STAFF REPORT: OCTOBER 9, 2024 MEETING

APPLICATION NUMBER: HDC2024-00514

ADDRESS: 2906 CASS

SCOPE: ALTER PARAPET AND CORNICE

Figure 3: Elevation showing the proposed parapet.

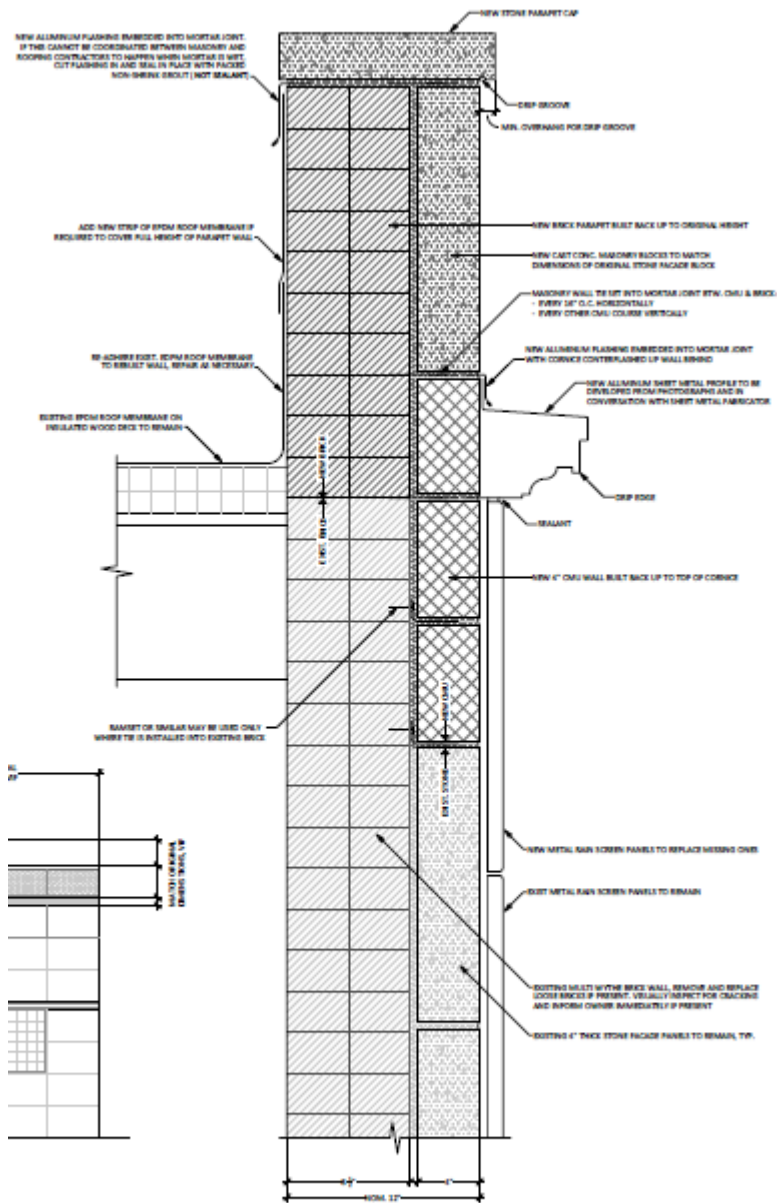
- Staff acknowledges reproducing matching carved stone details may be financially and technically impractical. However, it is staff's opinion recreating these carved features in a feasible and appropriate replacement material should be further investigated.

- It is staff's opinion that cast concrete blocks are an appropriate substitute material for the stone parapet. However, staff notes that the "cream color" of the block was the result of paint applied to cornice/parapet ca. 2009, prior to the establishment of the district. It is staff opinion that cast concrete block should be tinted to match the gray façade stone present beneath the metal panels, in the case that a future applicant/owner would seek to uncover the original façade. HDC staff can approve the painting of a new cornice to match the conditions at the time of designation.

- Staff also has concerns regarding the longevity of the formed aluminum cornice. While the proposed cornice may initially be a visually acceptable substitute for the original stone, it is probable that as the replacement feature ages and weathers that dents and scrapes will reveal the true material of the cornice.

The original stone parapet, with its classically derived carved stone detailing, was the remaining visible portion of the original façade, and helped to visually demonstrate the building's architectural evolution over the first half of the 20th century. The proposed replacement lacks the distinctive character defining elements of the original parapet and is not an appropriate replacement.

Recommendation – Denial – Alter Parapet and Cornice
